CITY OF ALBUQUERQUE

**RE: Honey Well – Docks and Parking Lot
Conceptual Grading and Drainage Plans
Engineer's Stamp Date: 06/18/24
Hydrology File: B17D001B**

**RE: Honeywell
9201 San Mateo Blvd.
HONEYWELL- DOCKS AND PARKING LOT GRADING AND DRAINAGE PLANS
HYDROLOGY FILE: B17D001B- RESPONSE TO COMMENT**

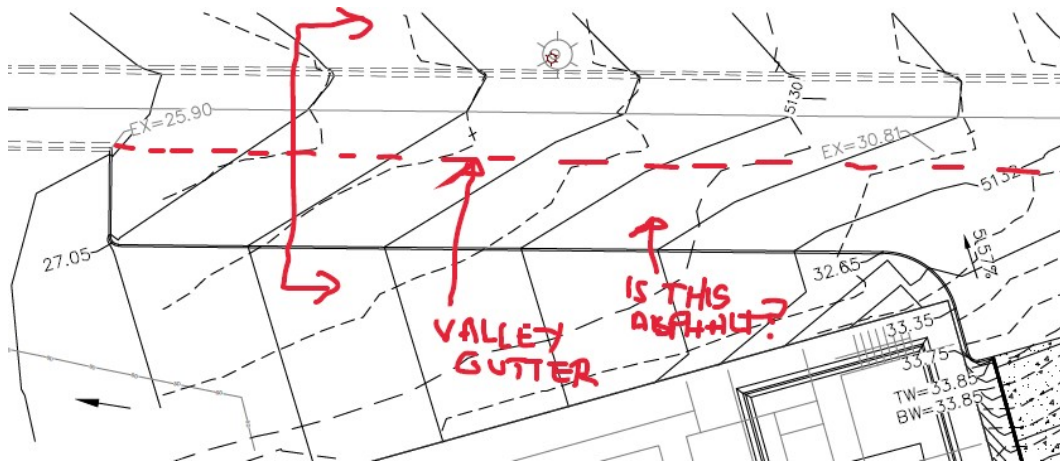
18. **Comment:** For Dock A Detail. Please provide the pipe size of the discharge pipe (force main). (please not that this will be under pressure so that the correct material needs to be used.) It states that this will discharge to a concrete slab. Please provide a detail showing this. This can be incorporated into the pump manhole detail.

Response: Pipe sizes are shown for all pipes and I have provided a manhole detail that incorporates the discharge to the concrete slab.

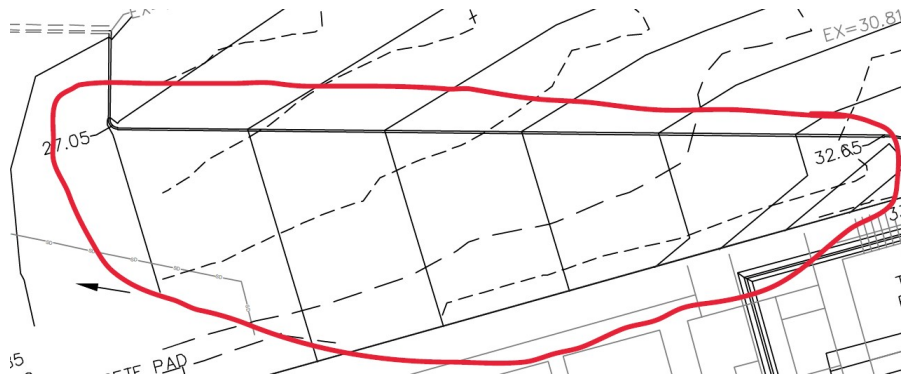
22. **Comment:** Please provide a typical section here.

Response: A typical section was added.

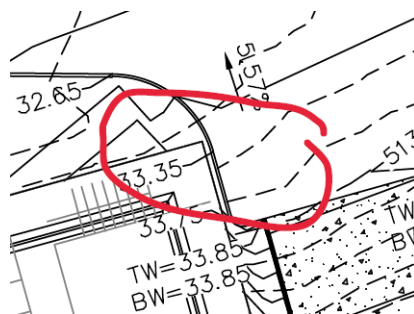
25. **Comment:** There are existing emergency doors at this location. I believe that there needs to be some sort of landing here and not just a curb. This needs to be brought up to the architect.

Response: This was caught and fixed. A landing was put in where the existing doors are.

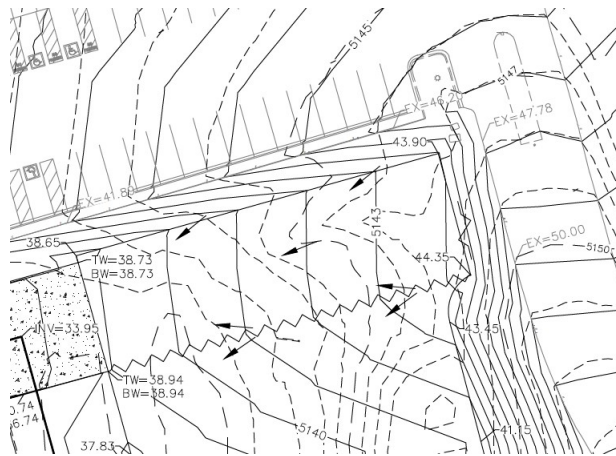
26. **Comment:** Please clean up the proposed dock areas. There should be no proposed elevations here. All proposed elevations need to be shown on the blow-up Detail of the dock.

Response: All proposed dock areas were cleaned up and shown as a low-up Detail on sheet C2.7.

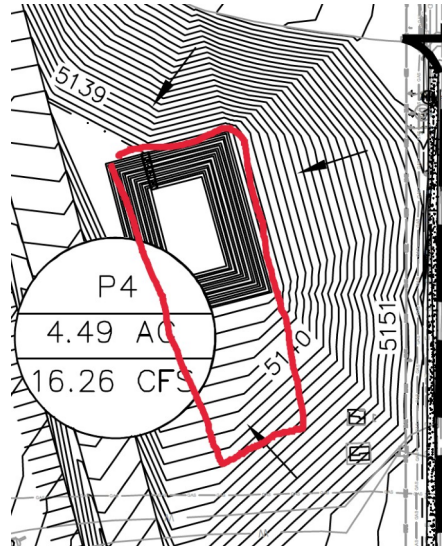
31. **Comment:** Please revisit the required retention pond design. I think that this could be designed a little bit better but please keep in mind to keep a side slope of 3:1 or provide a retaining wall if need be.

Response: The ponding was stretched south to reduce the depth from 8' to 5'. All sloping at the pond and to the pond is at 3:1 sloping.

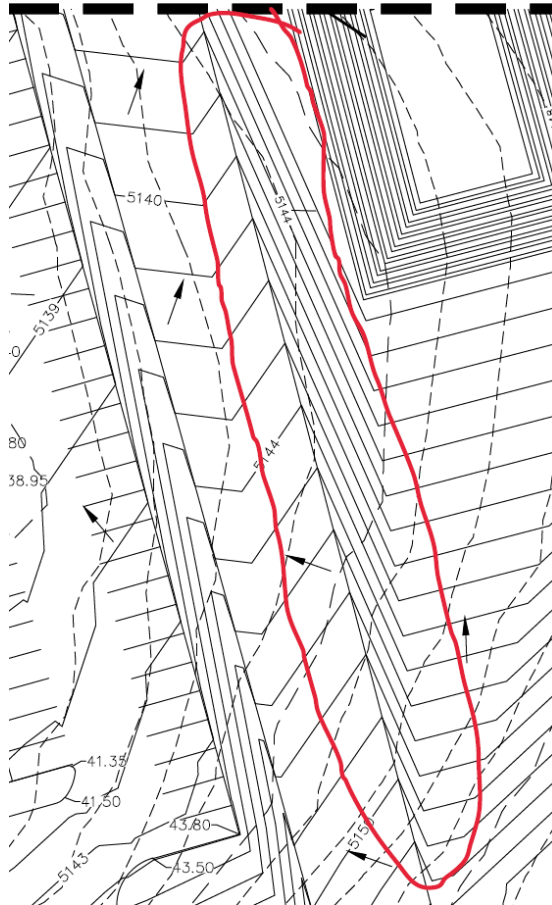
34. **Comment:** Please remove the word "Conceptual" in the sheet title.

Response: "Conceptual" was removed from title on all sheets.

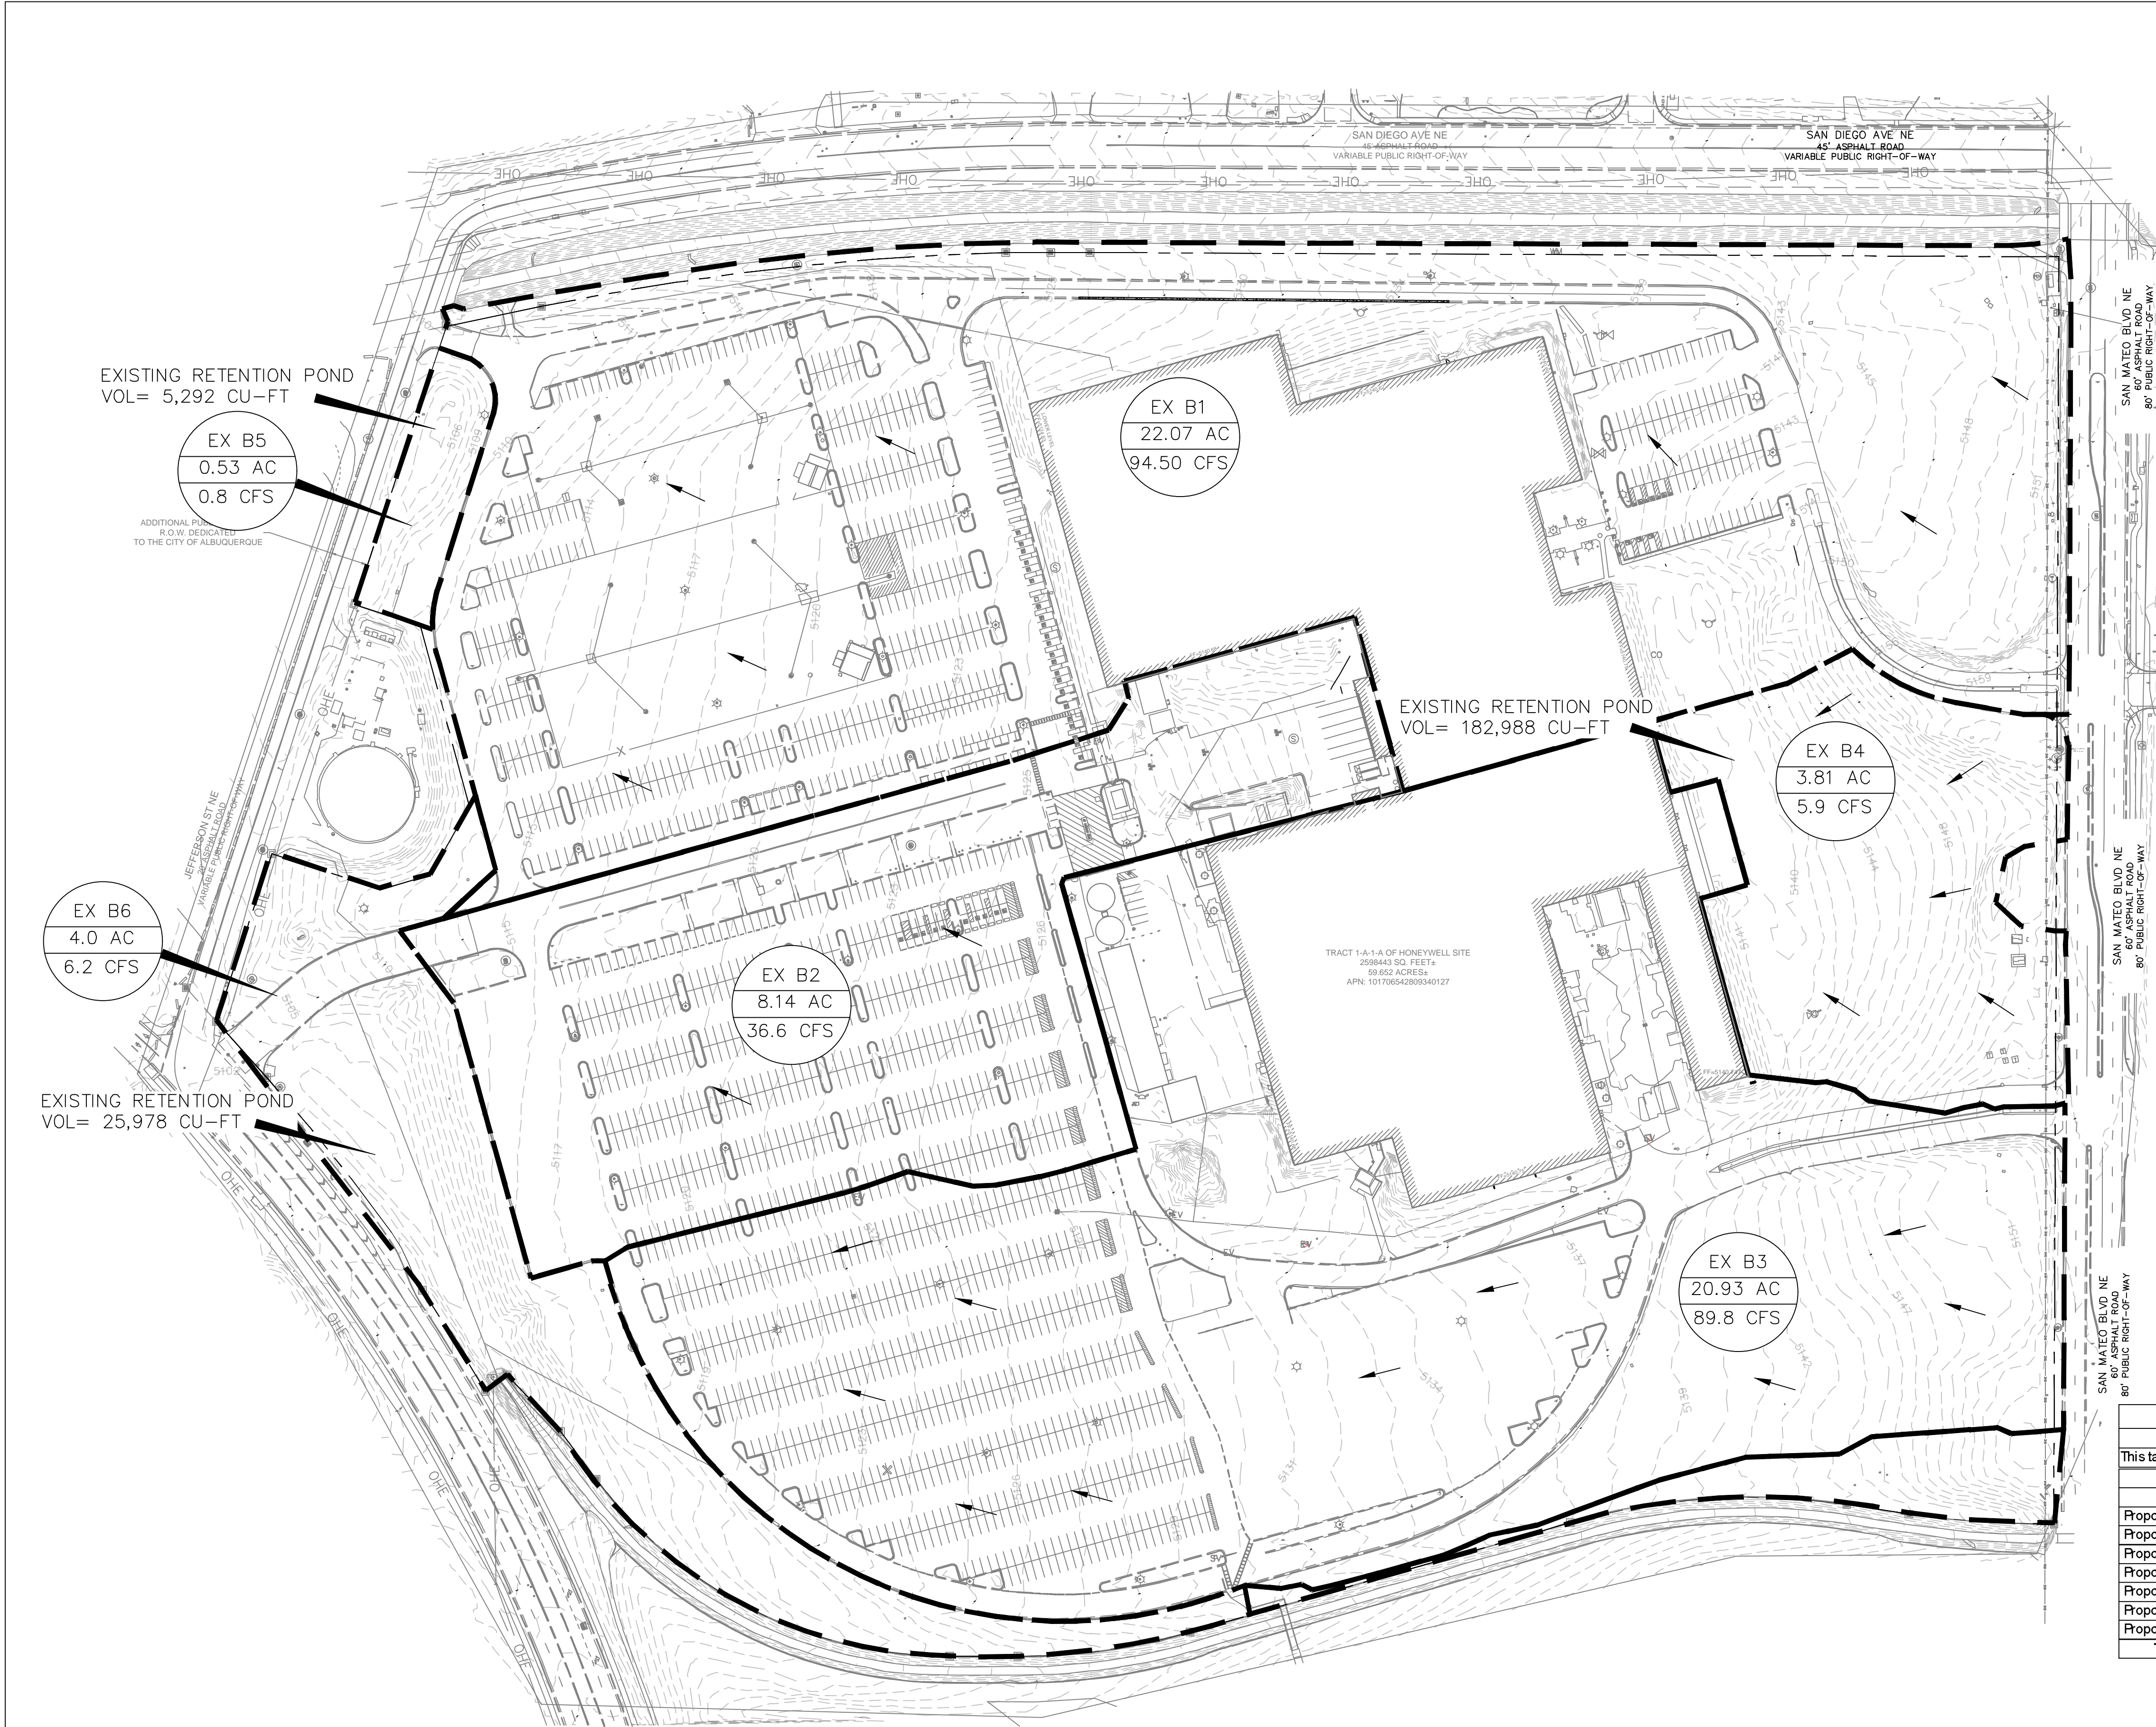
1. **Comment:** Please provide a Vicinity Map. This can be downloaded in pdf format from the City of Albuquerque's website.
Response: A Vicinity Map was added to sheet C2.0.

2. **Comment:** Please change the title of the sheet to "Overall Grading Plan".
Response: Sheet C2.0 was changed to say, "Overall Conceptual Grading Plan" due to the resubmittal being for conceptual.

3. **Comment:** Please fix the proposed contours. As discussed, this should only be the areas where there are grading work. Since the majority of the site is not going to be touched, this should be the existing contours only.

Response: Proposed contours were modified to be shown for only areas the proposed work is being done.
4. **Comment:** There should be an index contour line which is at every 5 feet interval. The index contour line should be a little bit thicker and labeled. The minor contour lines do not need to be labeled unless it is important.

Response: The line work and labeling for the surface was fixed.
5. **Comment:** Please scale back the existing contours.
Response: Existing contours were scaled back.

6. **Comment: Comment:** Please remove all of the architectural interior of the existing building. Instead please just show the outline of the building with a thick line with a hatch. It should look similar to the image below. **This applies to all sheets.**

Response: Remove all architectural interior of the existing building and have the building outline with a thick line and hatching showing.
